## Summary of Written and Oral Submissions

### Zoning By-law Amendment – 433, 435 Churchill Avenue North, 468, 472 Byron Place

Note: This is a draft Summary of the Written and Oral Submissions received in respect of Zoning By-law Amendment – 433, 435 Churchill Avenue North, 468, 472 Byron Place (ACS2020-PIE-PS-0105), prior to City Council's consideration of the matter on November 25, 2020.

### Document 3 – Revised Schedule YYY

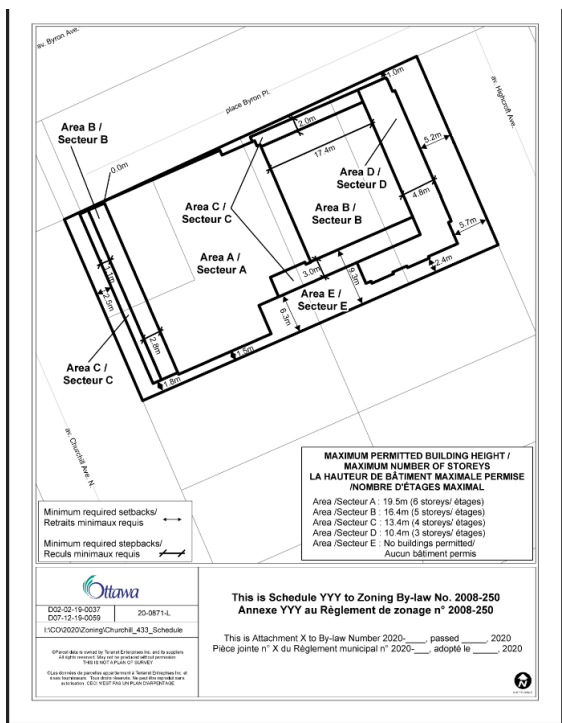
- a) Document 2, Details of Recommended Zoning, clause 3(c)(vi) be amended to replace “1.0 metre” with “1.5 metres” as it relates to the outdoor roof-top terraces; and
- b) Document 3, Schedule YYY, be amended by replacing Document 3 with the attached (see below).
